Fawn Lake Estates Preliminary Plat
#PrelimPlat-001036-2026

Development Review Committee Waiver Request Form

SUBMITTAL SUMMARY REPORT

PrelimPlat-001036-2026

SHT. 04.01

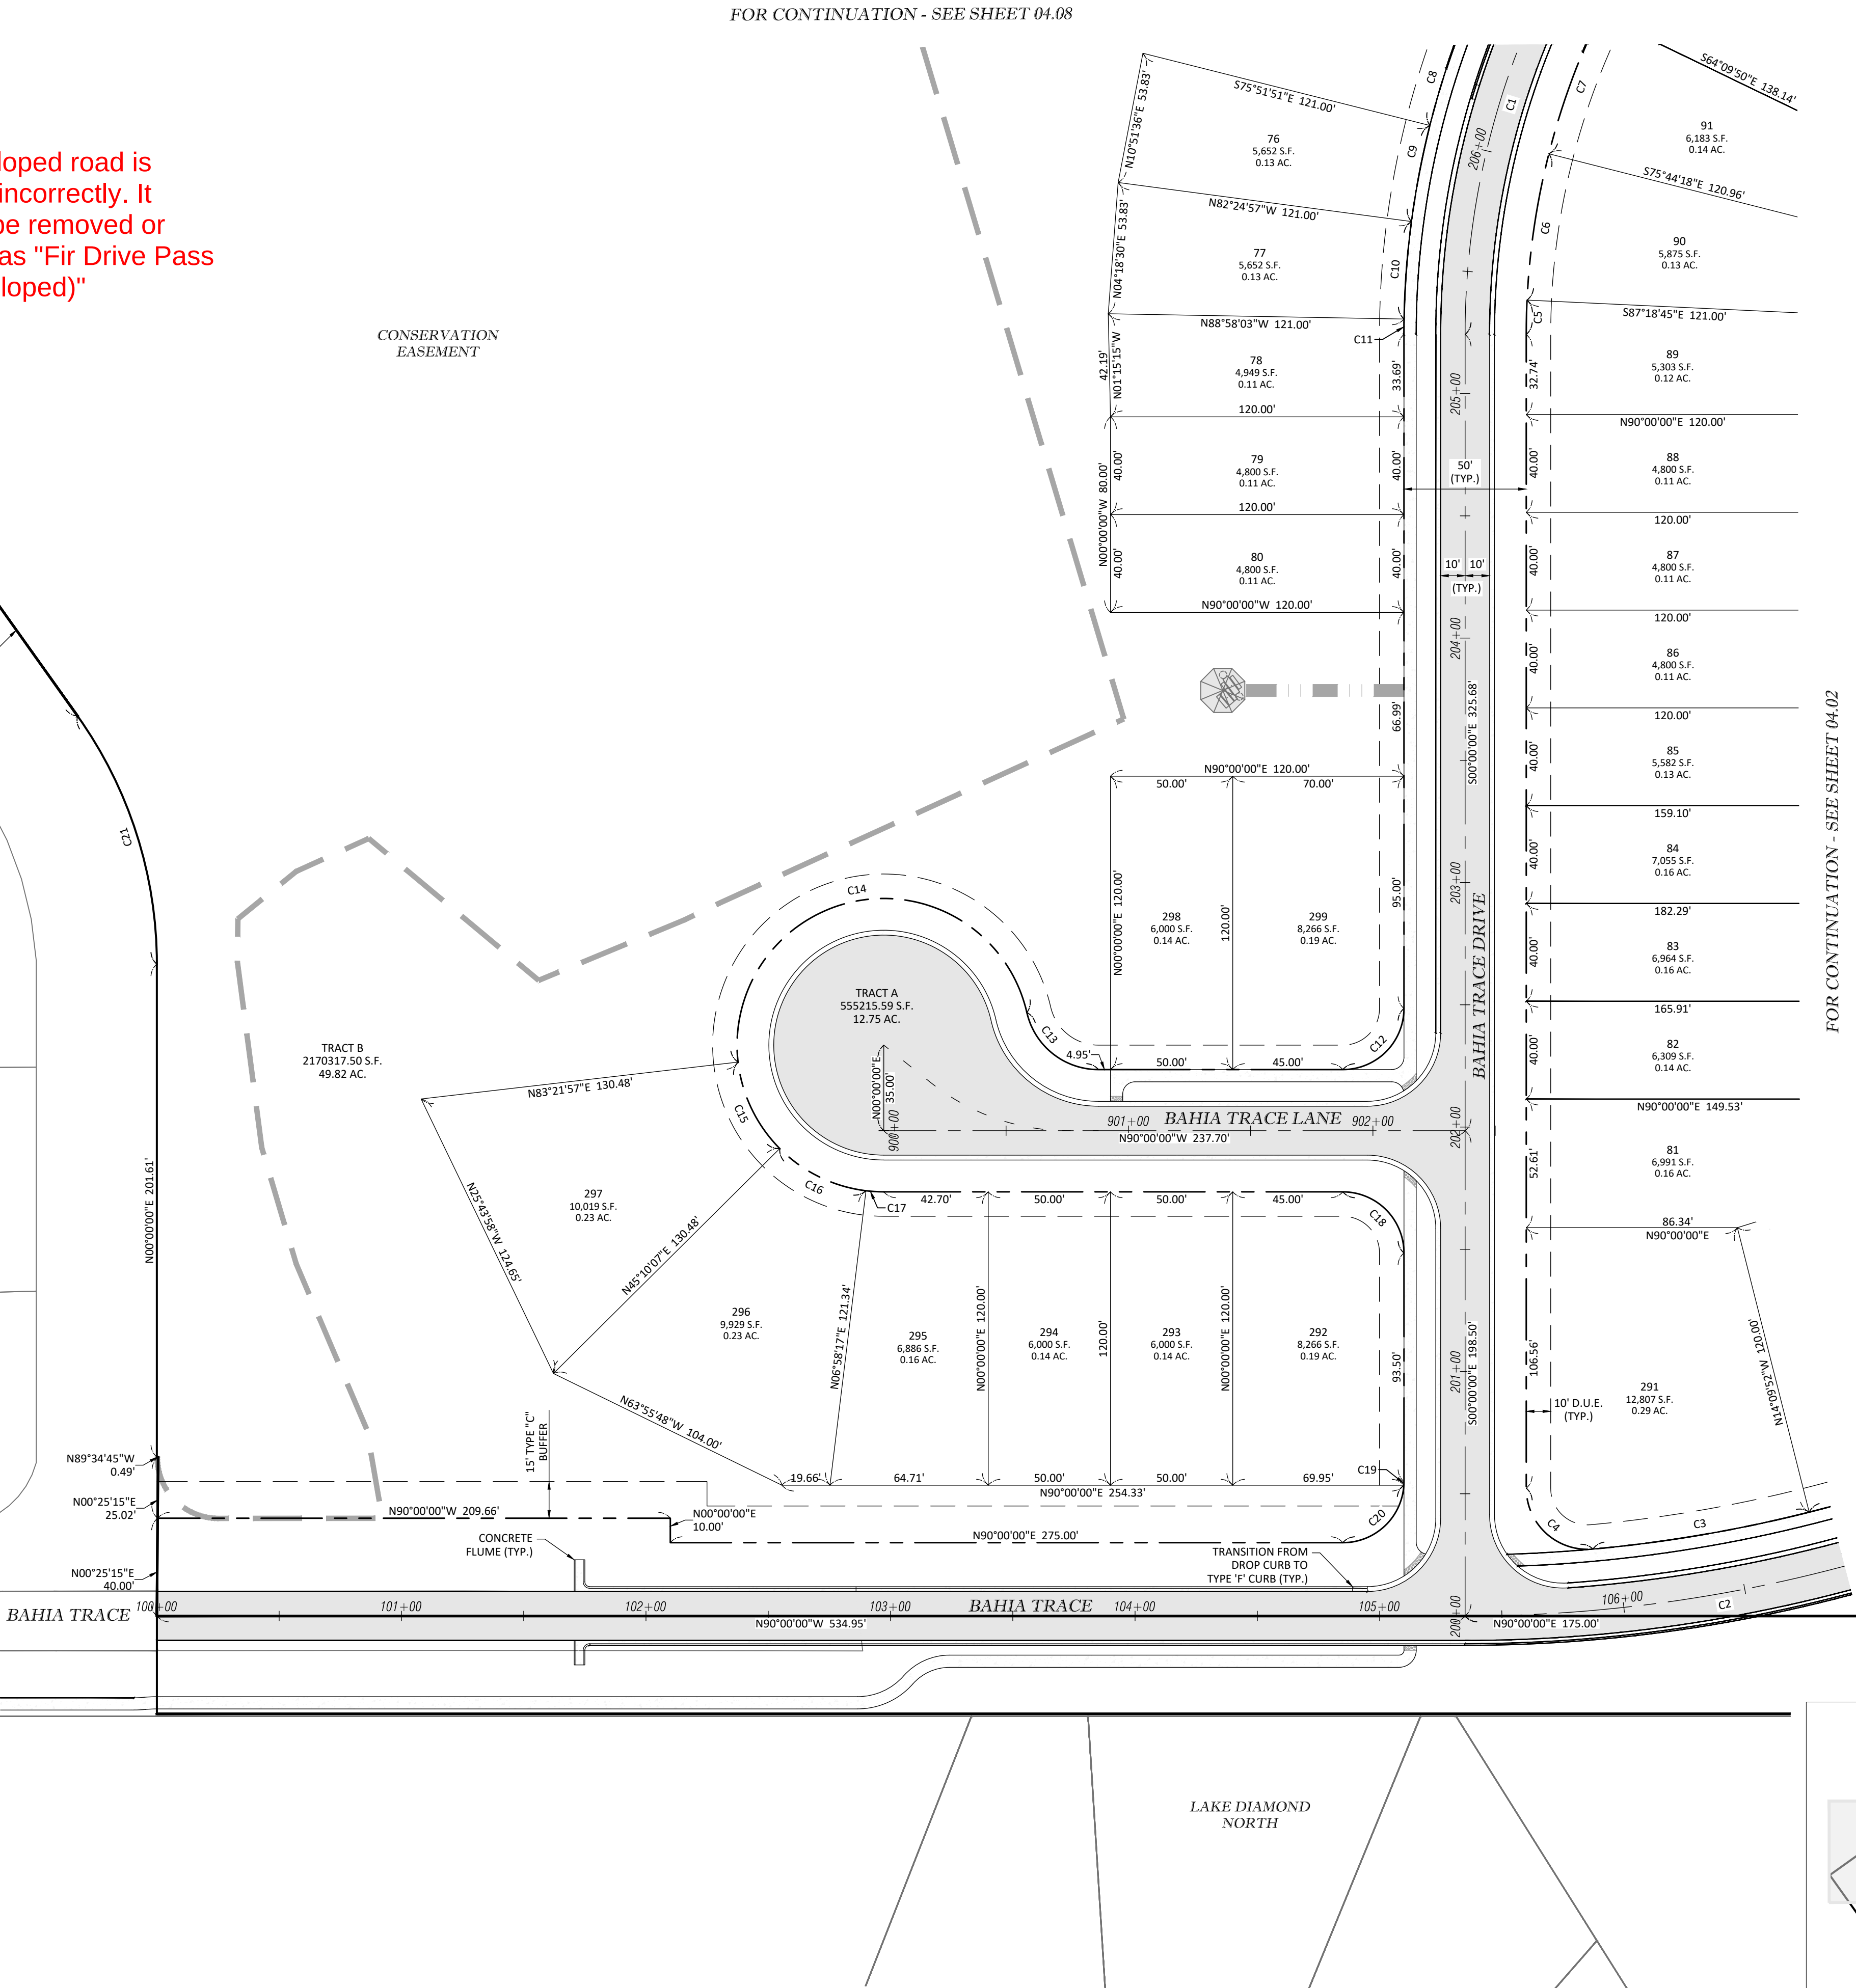
Undeveloped road is labeled incorrectly. It should be removed or labeled as "Fir Drive Pass (undeveloped)"

SHT. 04.08

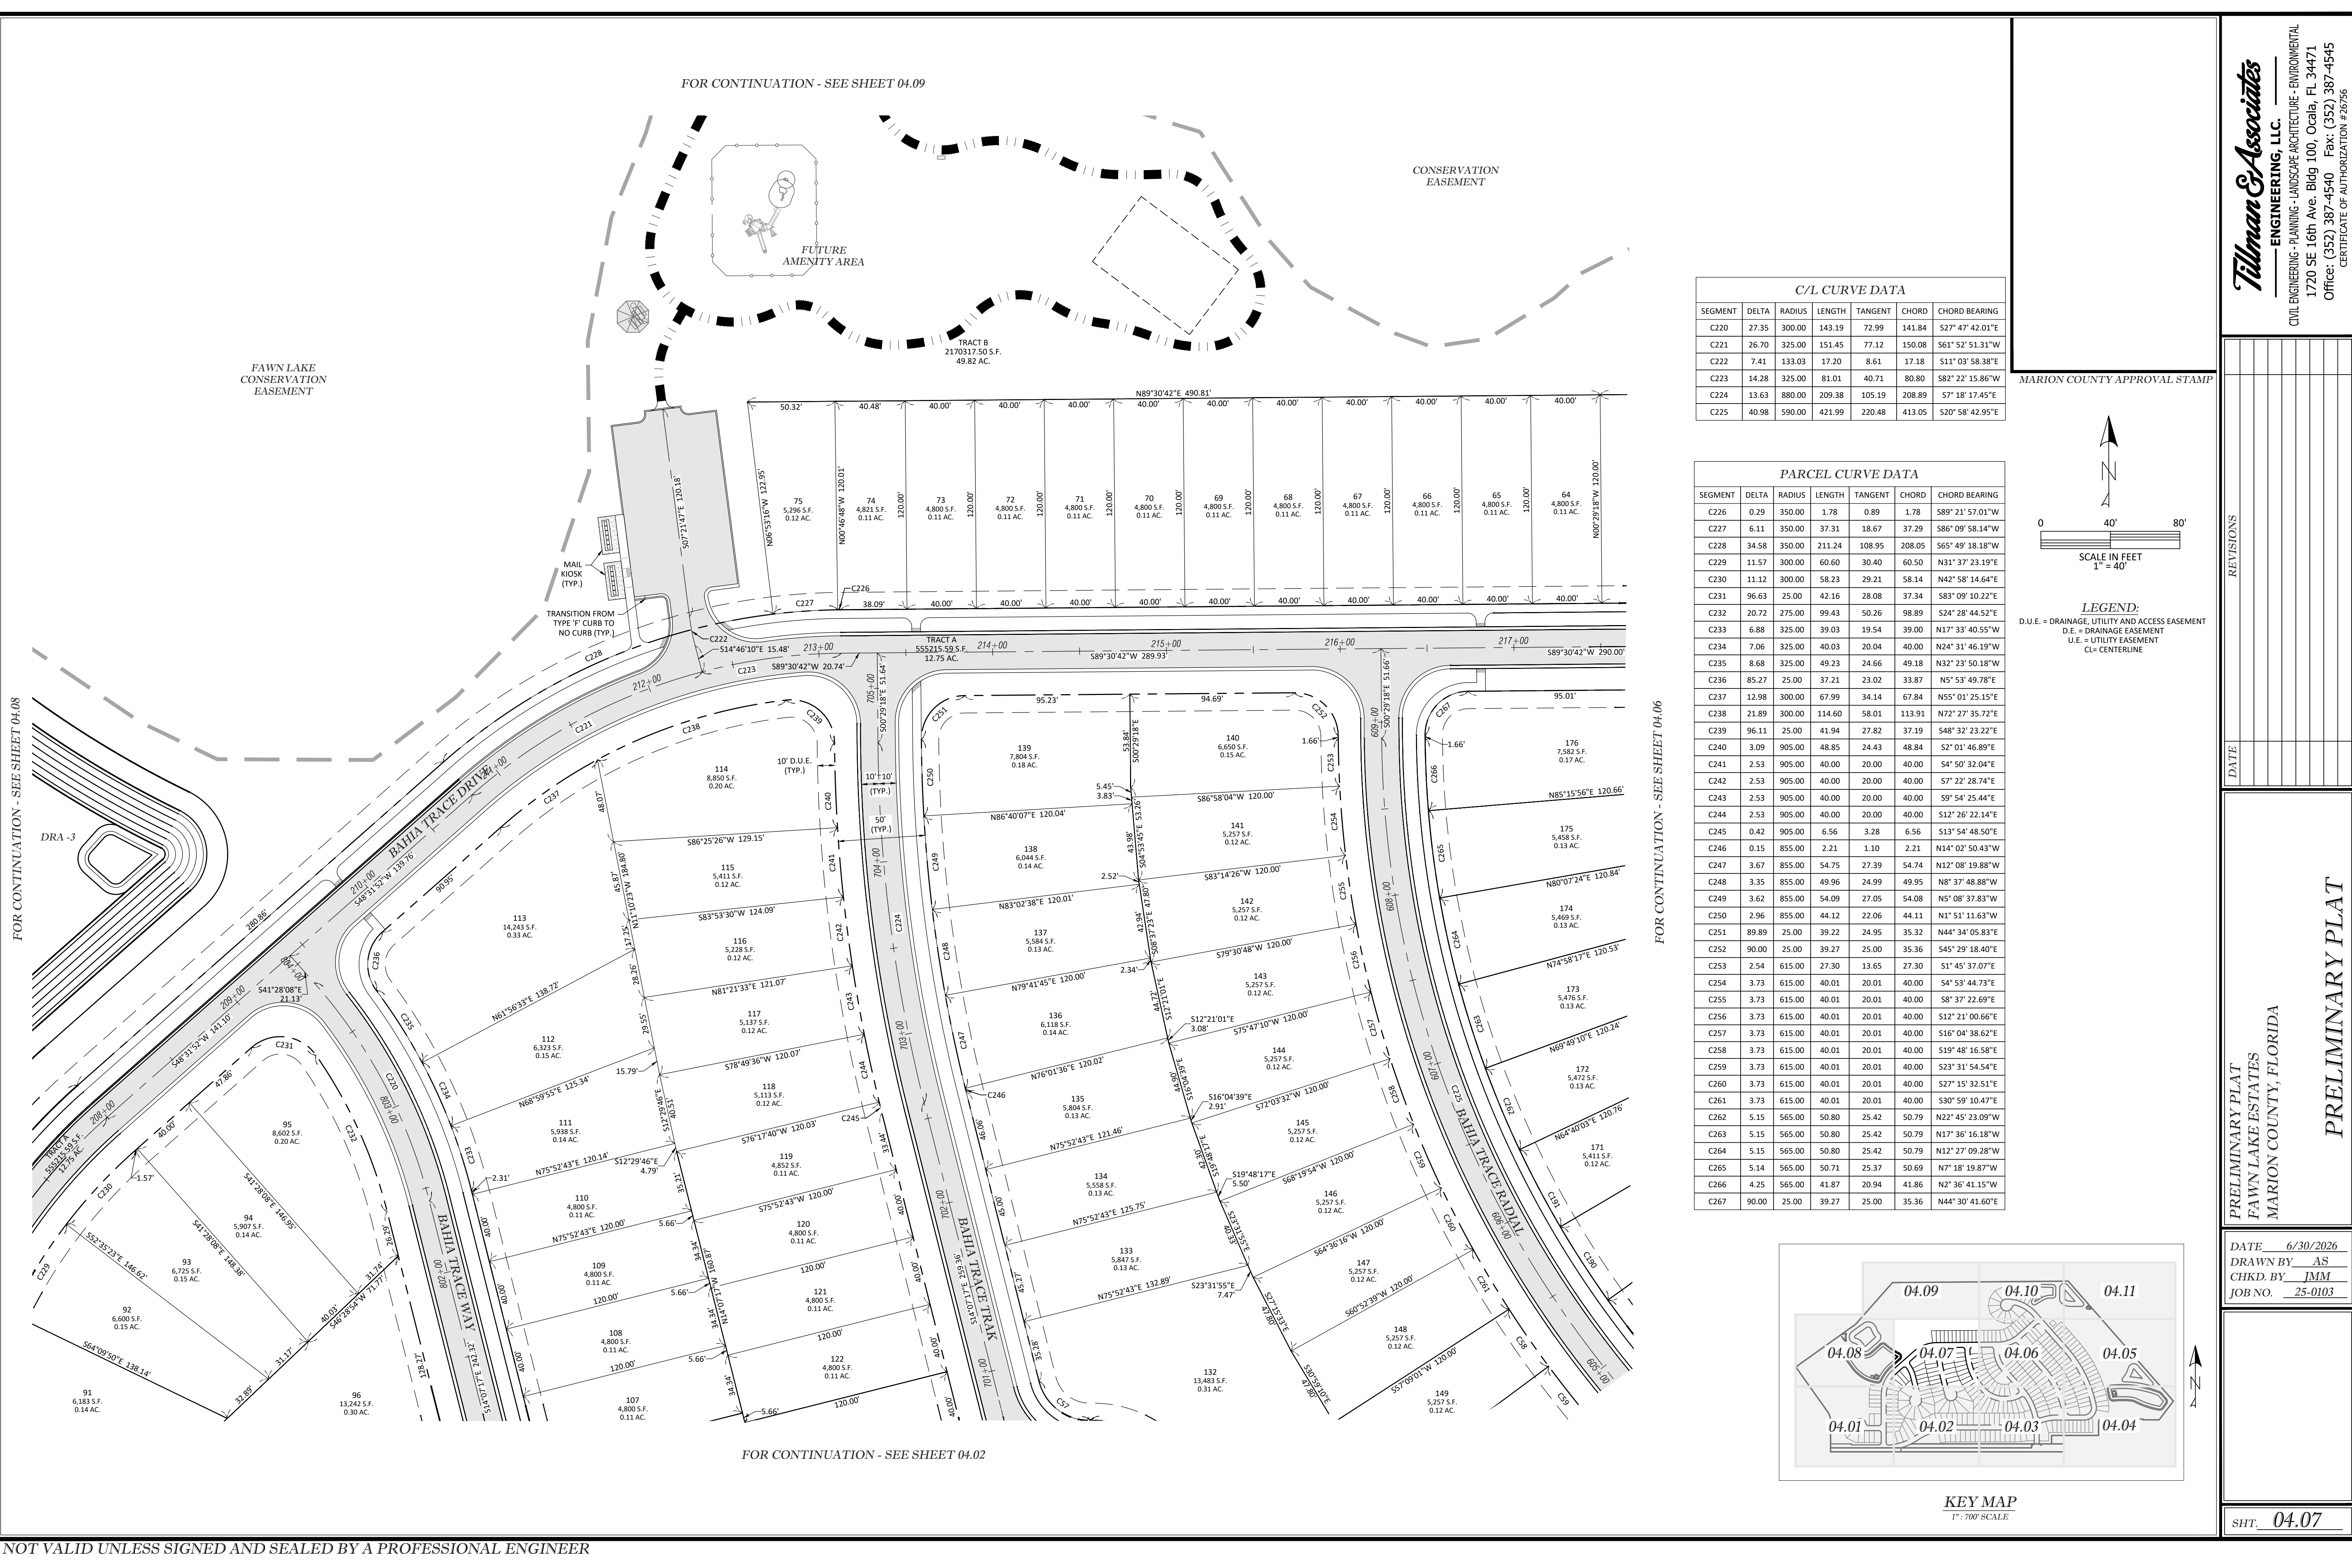
Undeveloped road is
labeled incorrectly. It
should be removed or
labeled as "Fir Drive Pass
(undeveloped)"
